THE HEMLOCK

DRB Recommendation Meeting
December 16, 2019
SDCI # 3033219

WH GREENWOOD, LLC

PHINNEY MASSING PRESENTED AT EDG 2 - NOT SUPPORTED BY DESIGN REVIEW BOARD

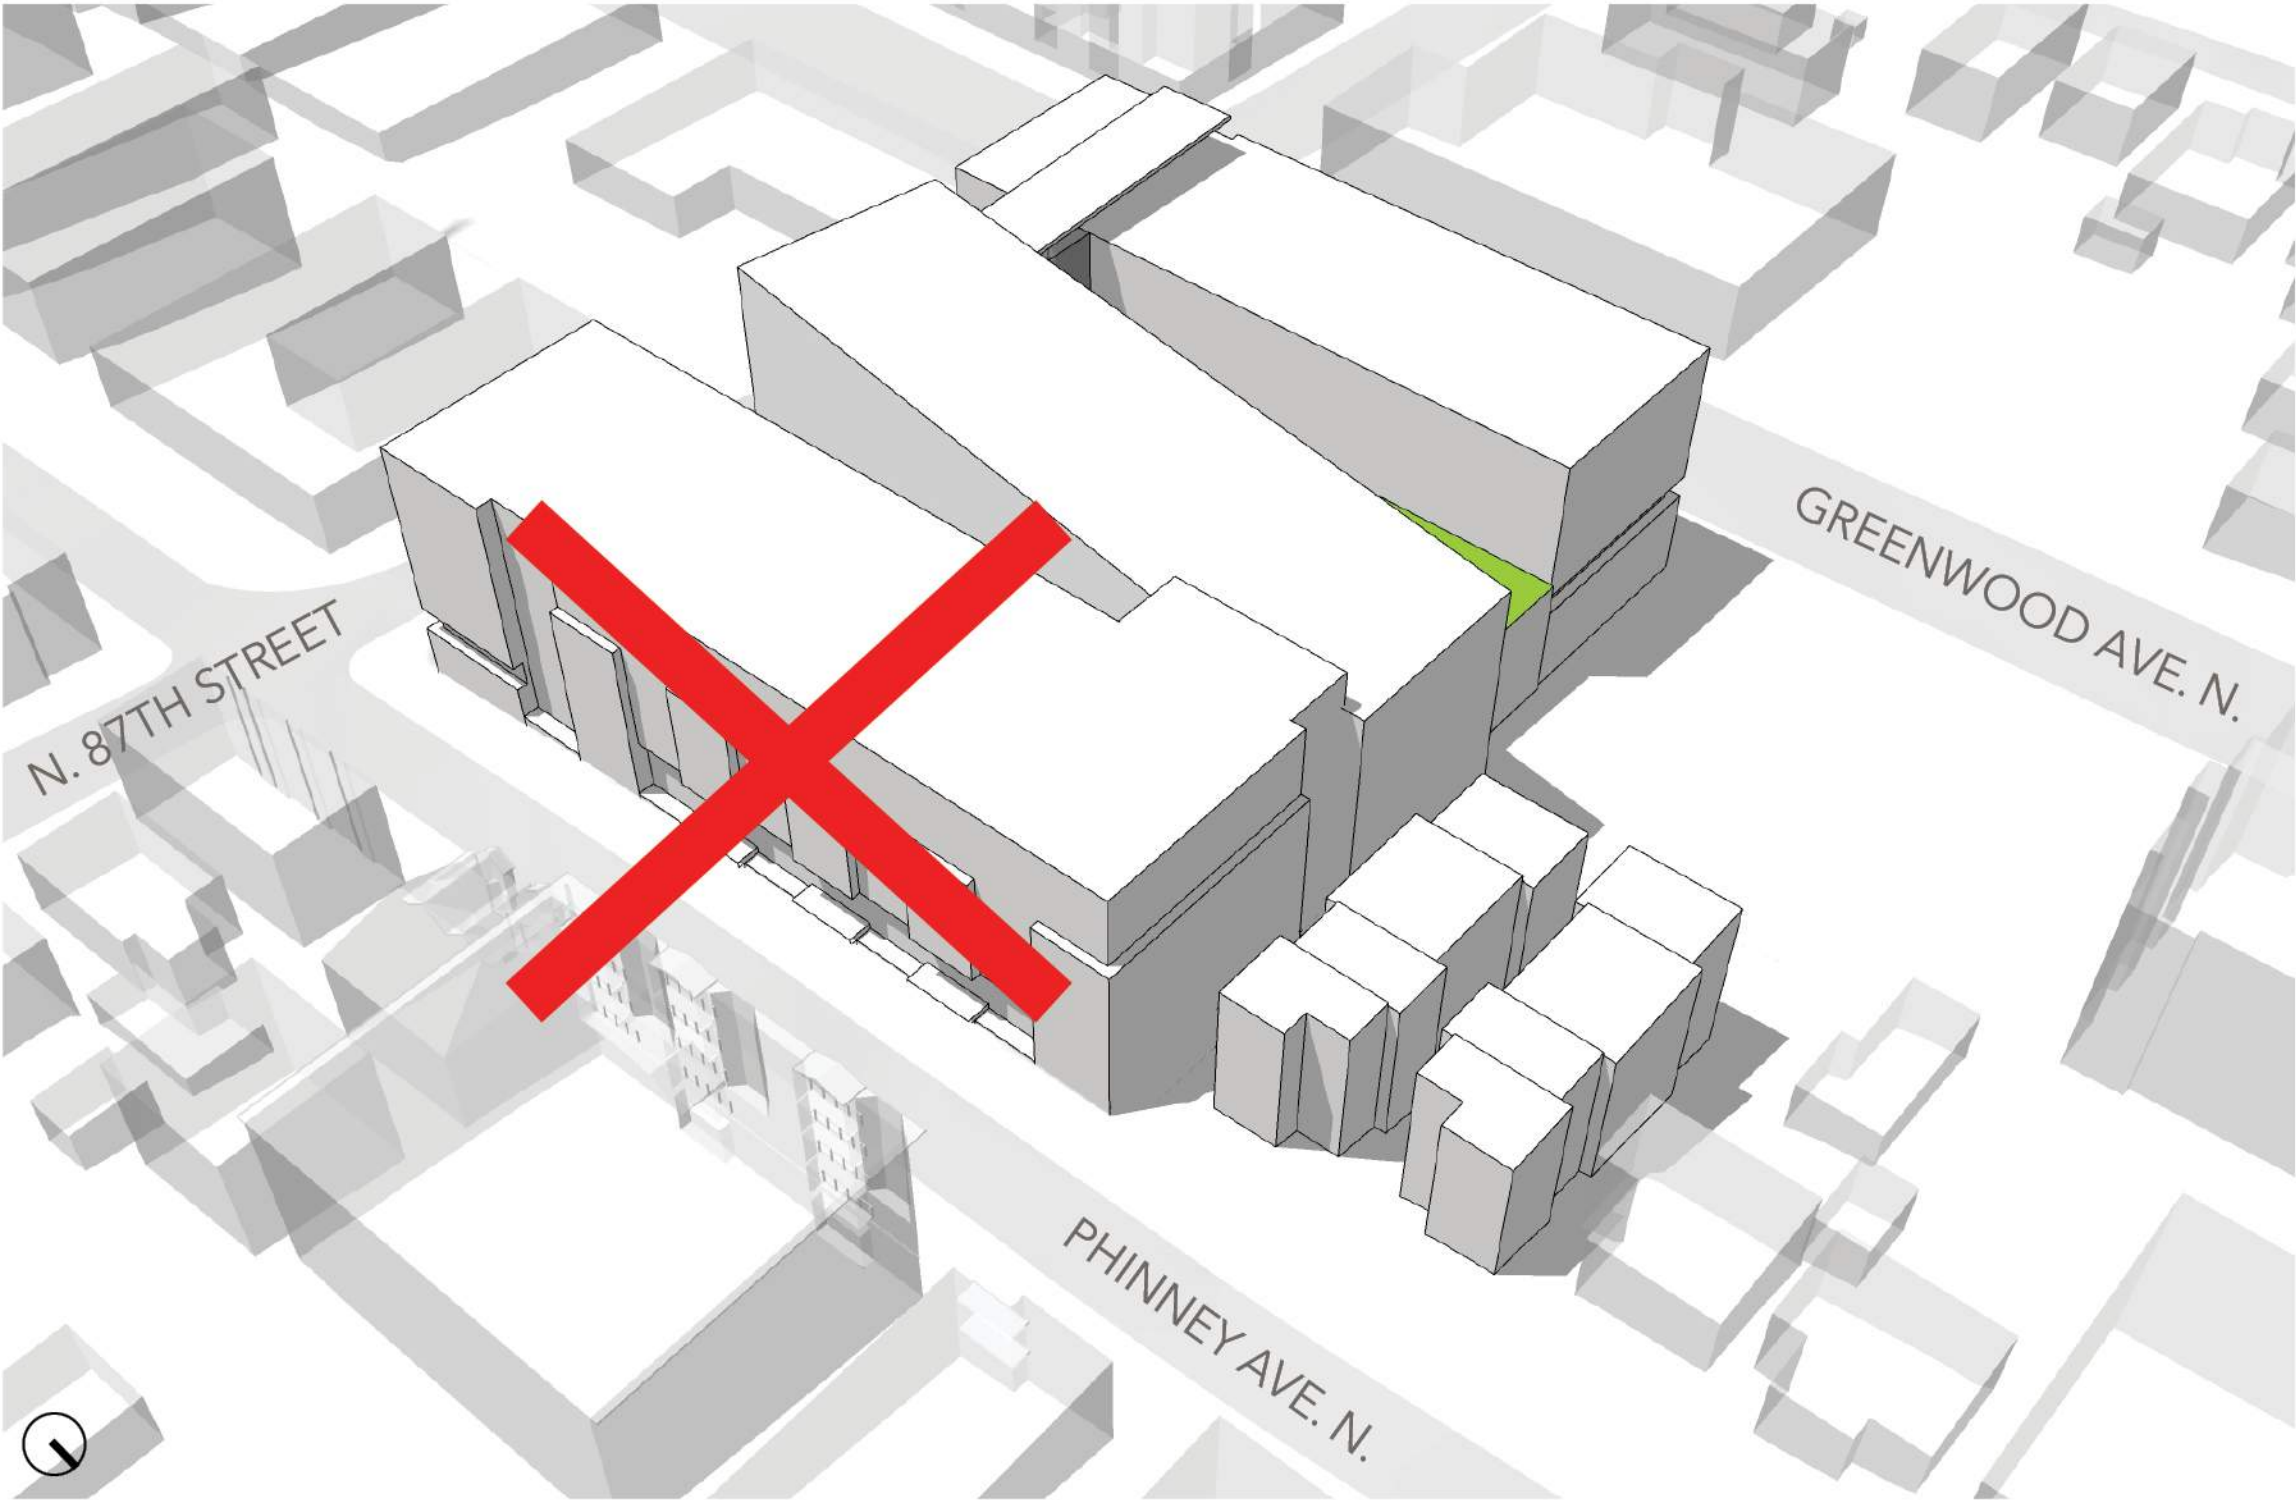
1a. The Board continued to support the “Three Bars” design concept but suggested that a strong secondary concept be developed for Phinney in response to existing development and the zone transition along this edge. (DC2, CS2-II-ii., CS2-D, CS2-VII-i.)

Response:
Greenwood/Phinney Design Guidelines (CS2.II.i) suggests the following techniques at zone edges. Our project directly addresses 3 of the 4 suggested strategies:

"a. increasing the building setback from the zone edge at the ground level;

b. reducing the bulk of the building's upper floors nearest to the less intensive zone;

d. using extensive landscaping or decorative screening."

BALANCE MASSING WITH SECONDARY PEDESTRIAN ENTRY CARVE

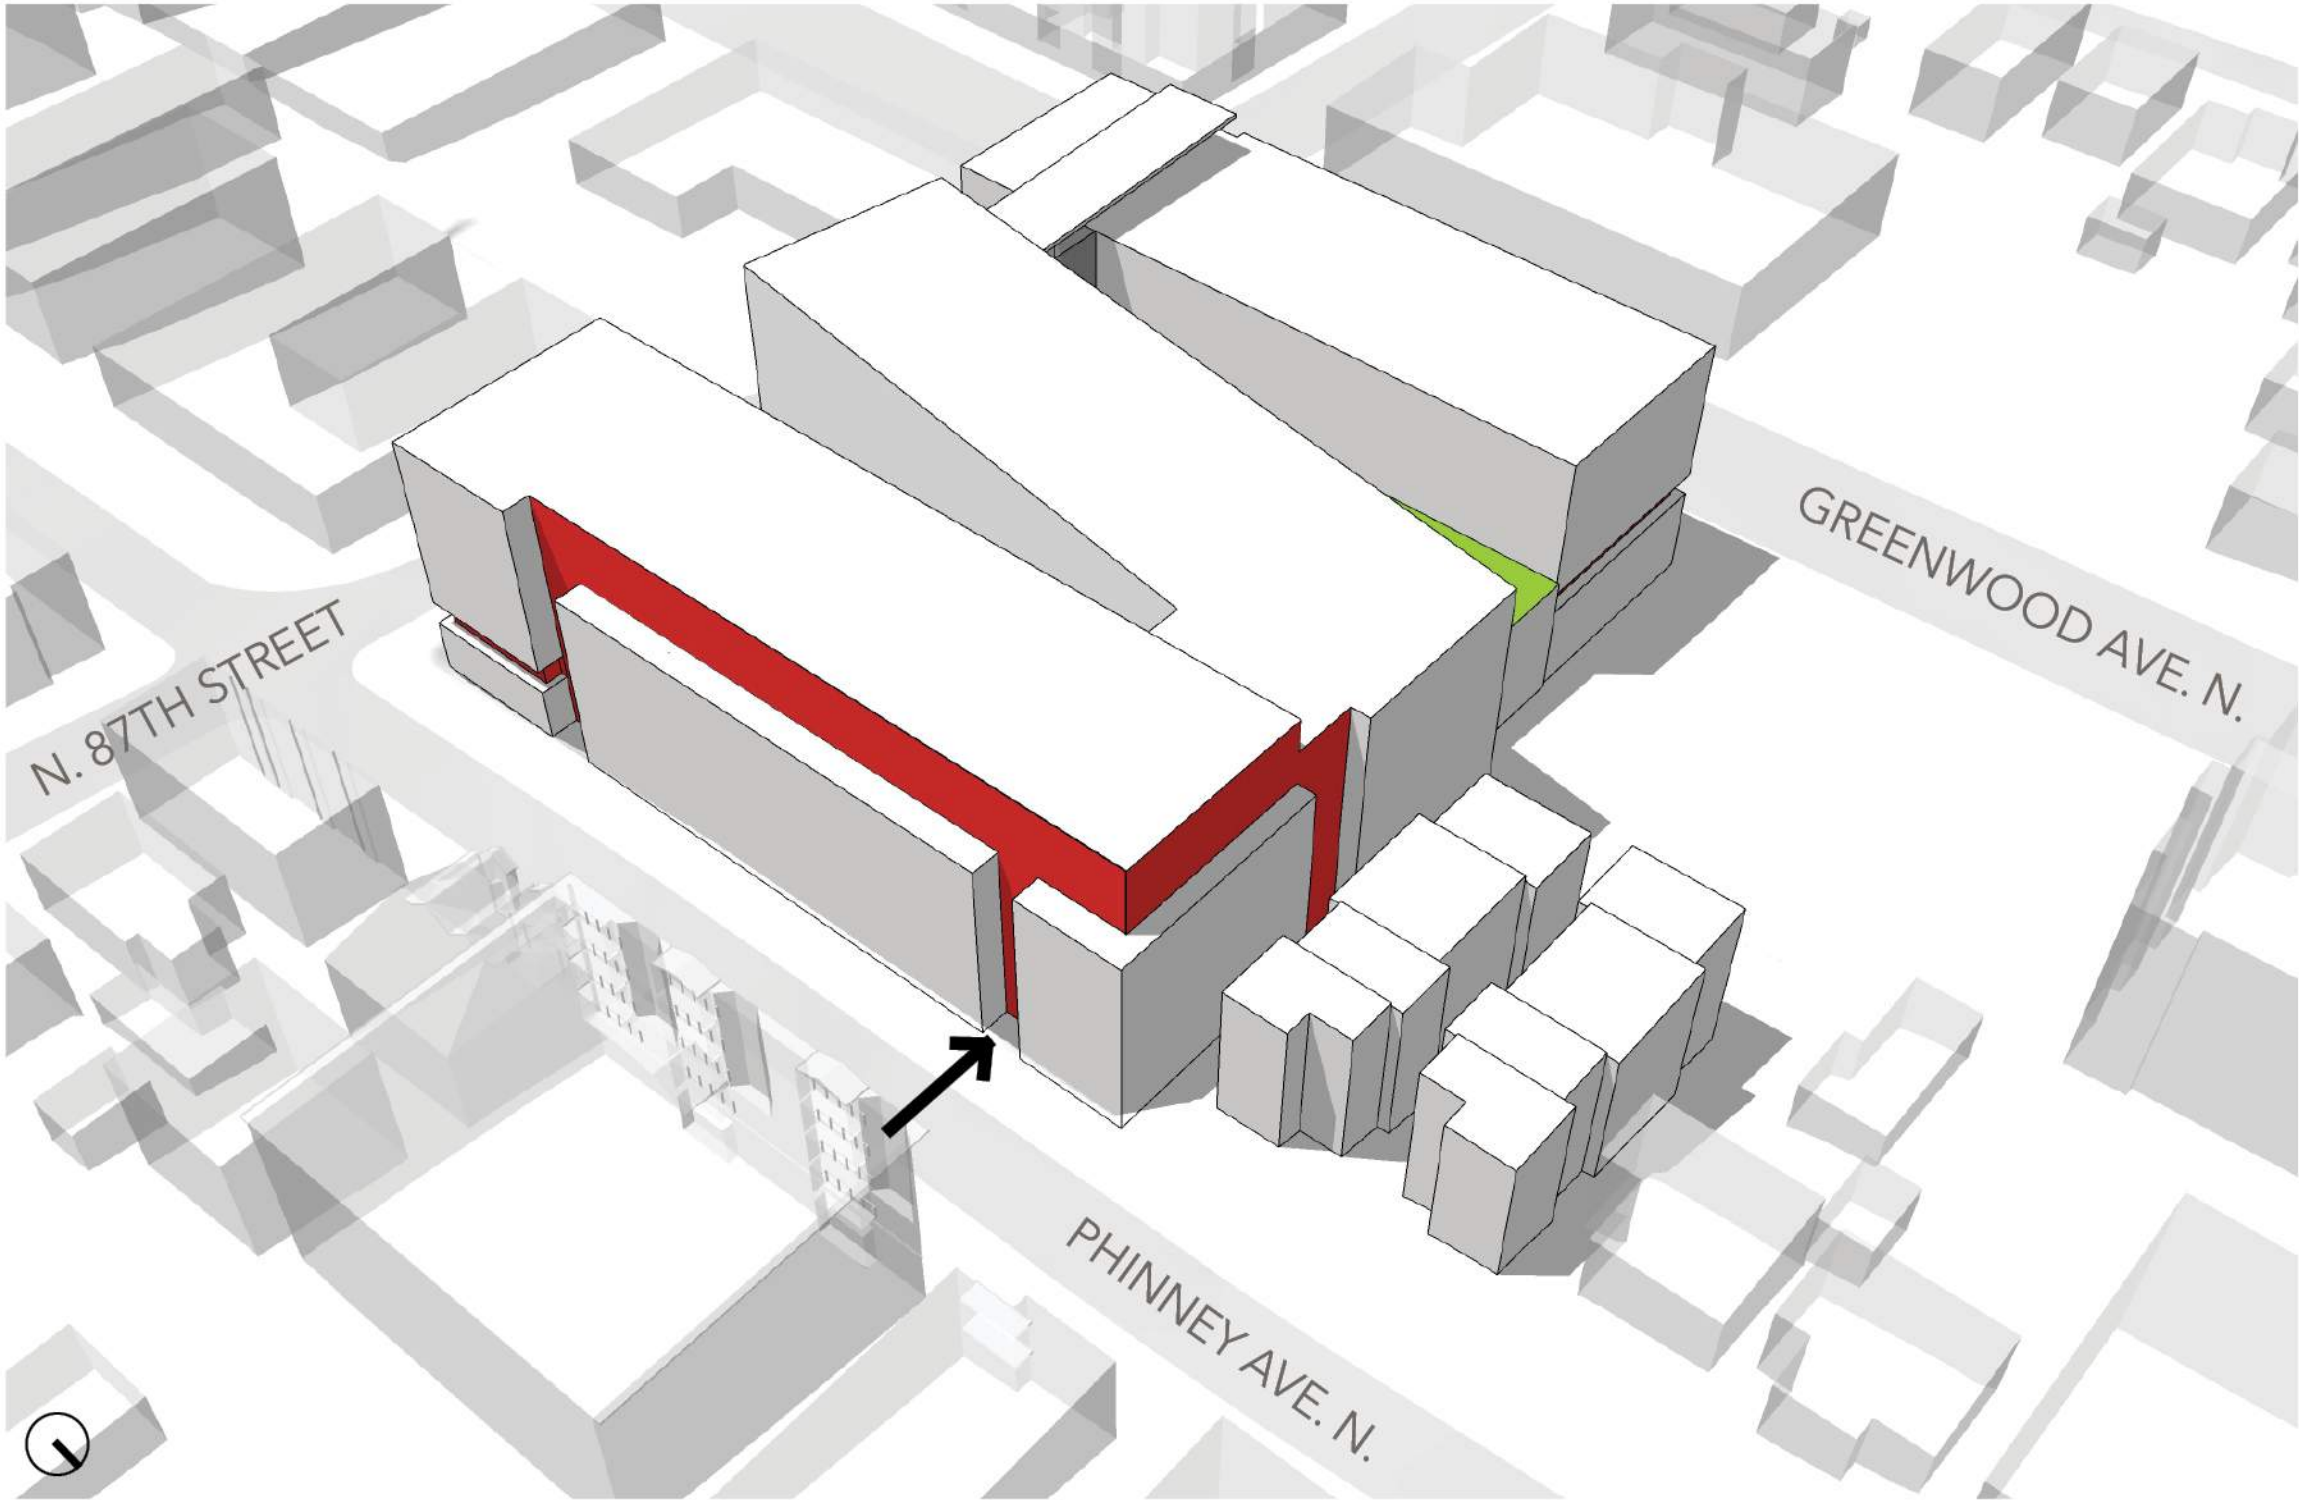
1c. The Board agreed that while they supported the thinking behind some of the secondary modulation, those elements seemed to occur only at the surface, and that larger massing moves would be required to mitigate the length, scale and bulk of the project. (CS2-II-ii., CS2-D, DC2-III)

Response:
A secondary vertical "reveal" element which provides a secondary means of egress has been introduced at the north end of the Phinney facade. This breaks down the Phinney facade to a greater extent and adds variation to the vertical modulation introduced in the next diagram.

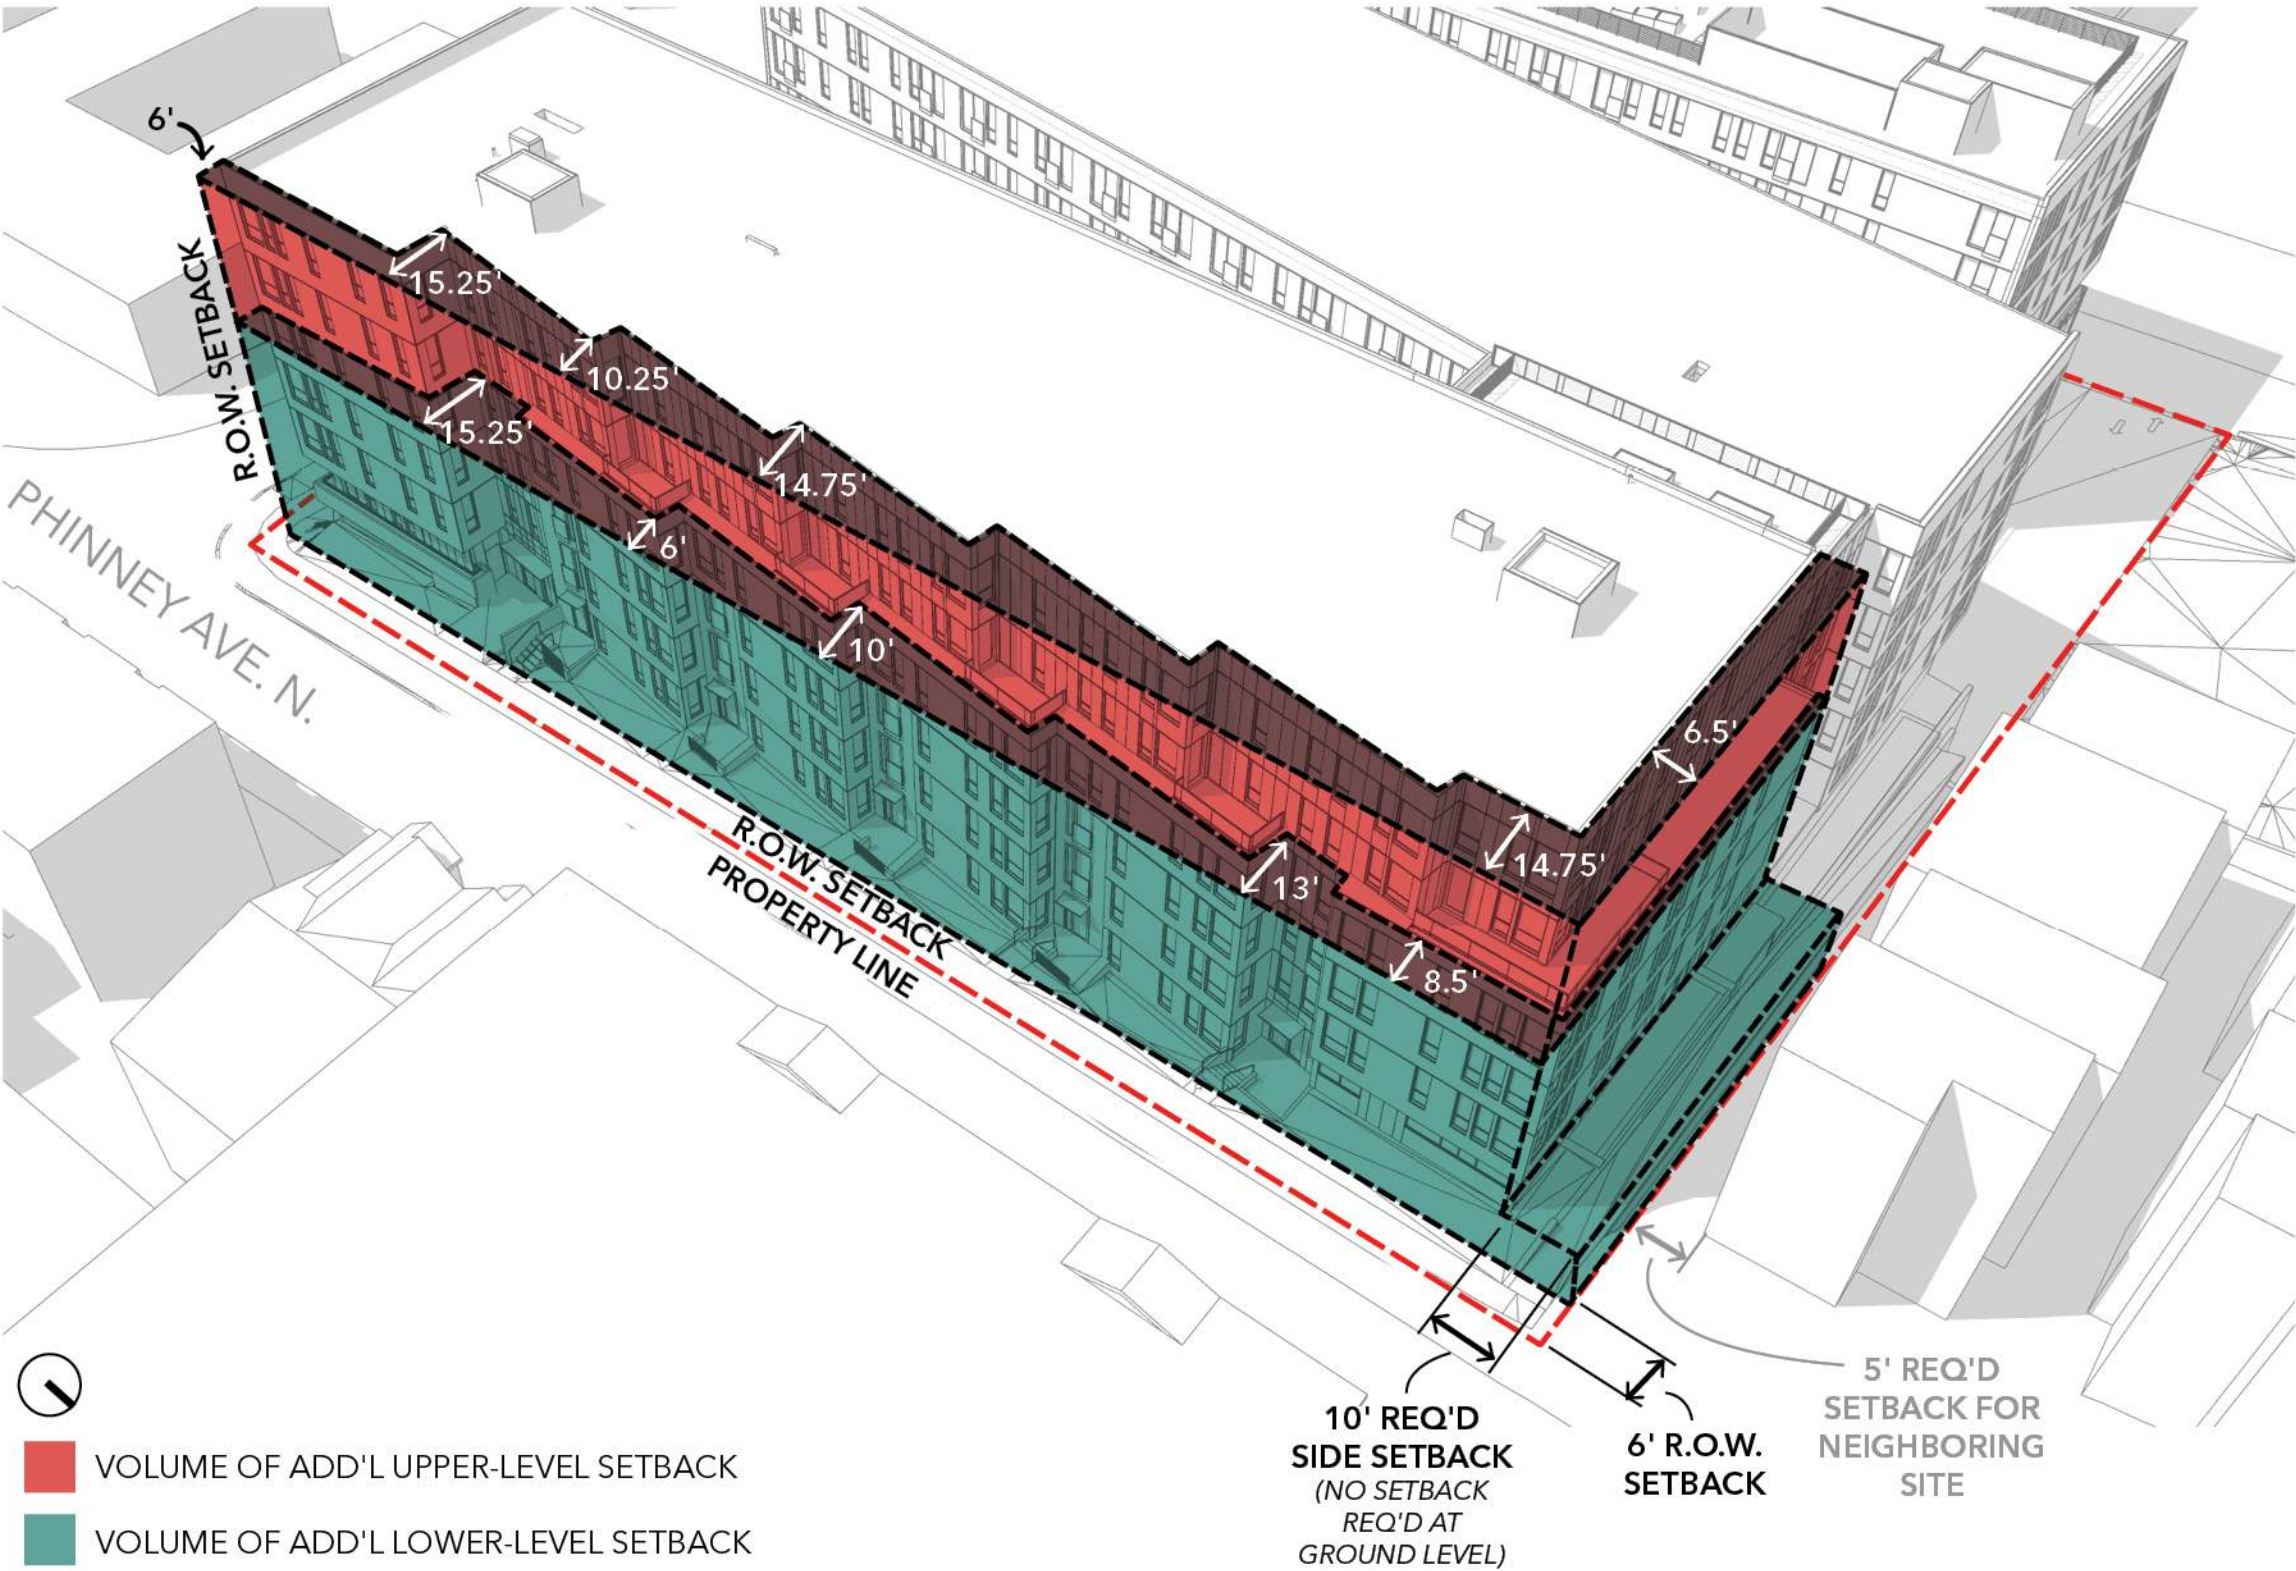
1b The Board noted that the revised design had not gone far enough in breaking down the scale of the project on Phinney Avenue, and that this scale breakdown was not possible with secondary elements alone. (CS2-II-ii, CS2-D, DC2-III)

Response:
A larger massing move has been introduced (as described in the Phinney facade transformation diagrams.)

The volume that the building is set back from the property line **in addition to the required R.O.W. setback** is highlighted in the diagram to the right.
